Interactive comment on “Technical note: Stage and water width measurement of a mountain stream using a simple time-lapse camera” by Pauline Leduc et al. (HESS 2017-285)

10 octobre 2017

FIGURE 1 – The different distribution used to set the thresholds

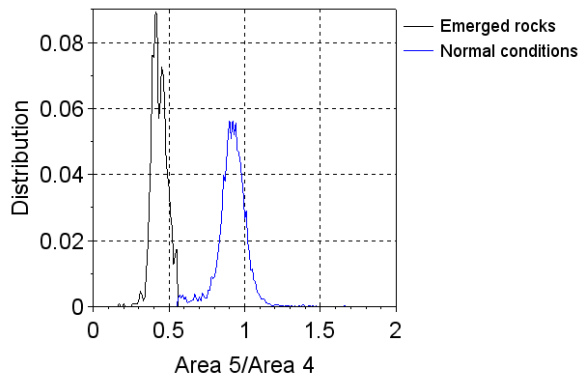
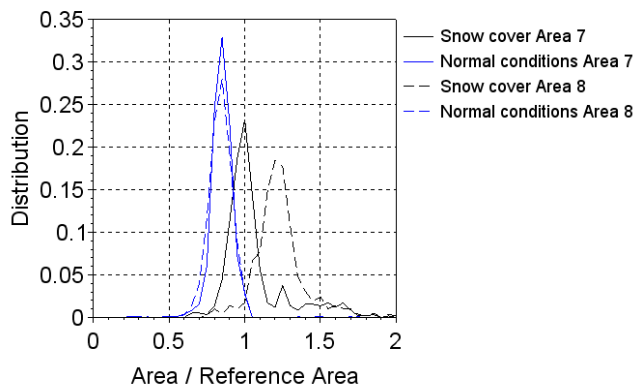
Therein lies my main concern-the clever filtering techniques that are an improvement on Gleason et al may not work everywhere. The authors need to more clearly define their threshold values, and I think distributions of intensity in each of the eight regions should be shown at multiple flow levels to prove their utility beyond taking the authors’ word for it. Precise values are given in Table 1, but not in the text, and no distributions are shown. The reported wave issues are also troubling for the site selection issues discussed above. How much of an issue would these be in a different site ?

We illustrate the method for the particular site for which we sought a stage record. We did not choose the site for its particular characteristics, we were trying to get a stage record for the site given the characteristics that it had. We are not sure what is vague in our descriptions. One need not seek particular site characteristics for this method, but the image selection criteria would need to be customized for the site. This is partly a ‘trial and error’ method but once established for a site, which is not a lengthy process, it is automated. The threshold issue is the key point of our picture classification. However, we don’t want to focus too much on the 4 threshold settings for this particular site as they would need calibration for a different site. Our focus was to show the method. We can add an appendix with the threshold curves if this would be useful (see below, figure 1).

We are not sure what is being requested here. The filtering will need to be customized for a particular site (as it was in Gleason et al.) but the process is general. As the comment says, we have given values in Table 1, so we are not sure why repetition in the text is necessary. Note that the image regions are well outside the channel so are not affected by flow level except in the case of removing mid-channel rocks from the width estimation which would not be an issue in channels with large relative depth. We are not sure what the concern is with waves. We have explained this feature of the flow and one would need to be aware of it, but the stage signal can be filtered to account for these if necessary (as it is in any stage recording in an open channel) and we show coherence between the open water level and the logger level in a pipe.
